**UNITED STATES ENVIRONMENTAL PROTECTION AGENCY
BEFORE THE ADMINISTRATOR**

IN THE MATTER OF	*	PETITION FOR
	*	OBJECTION
Clean Air Act Title V Permit No. 2560-00292-V1	*	
	*	
	*	
for South Louisiana Methanol	*	Permit No. 2560-00292-V1
	*	
Issued by the Louisiana Department of Environmental Quality	*	
	*	
	*

PETITION REQUESTING THAT THE ADMINISTRATOR OBJECT TO THE ISSUANCE OF THE PROPOSED MODIFIED TITLE V AIR PERMIT NO. 2560-00292-V1 ISSUED BY LOUISIANA DEPARTMENT OF ENVIRONMENTAL QUALITY TO SOUTH LOUISIANA METHANOL, LP FOR THE ST. JAMES METHANOL PLANT IN ST. JAMES, LOUISIANA.

Figure 2: Internal floating roof tanks with column-supported cone roof (left) and self-supporting geodesic dome (right)¹⁵²

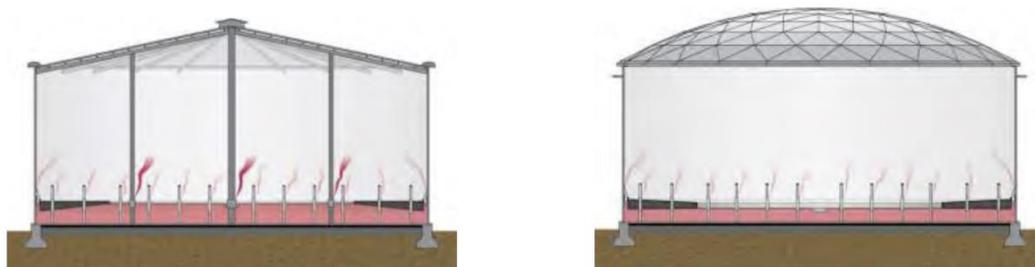
Regardless of the details of the inerting method, traditional internal floating roof tanks with column-supported cone roof tanks, as proposed here,¹⁵¹ have substantially higher VOC standing losses than self-supported geodesic domed internal floating roof tanks due to the penetrations in the floating roof for the legs supporting the cone roof which allow vapors to escape into the air space above (vapor emissions indicated in red in Figure 2). As explained below, BACT for the methanol product tanks is a welded cable-suspended internal floating roof tank with a geodesic dome. If required for safety and product integrity, an inert gas blanket can be used if VOCs trapped in the inerting gas are not emitted.

Figure 3: Leg-supported internal floating roof (left) and suspended internal floating roof (right)¹⁶³

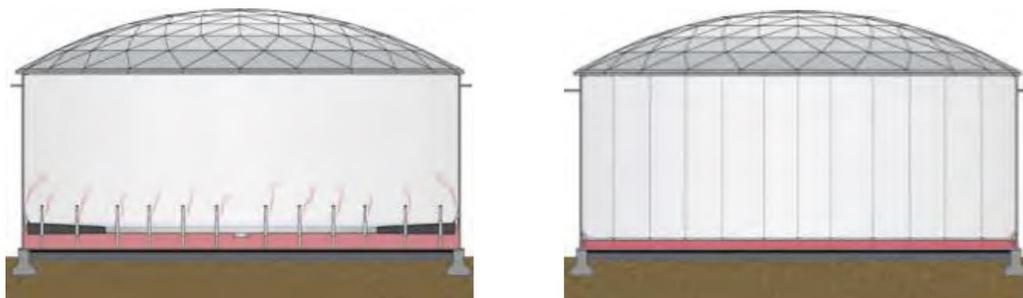
Emissions from internal floating roof tanks with geodesic domes can be further reduced by eliminating the leg-supports and instead suspending the internal floating roof with cables, as shown in Figure 3.
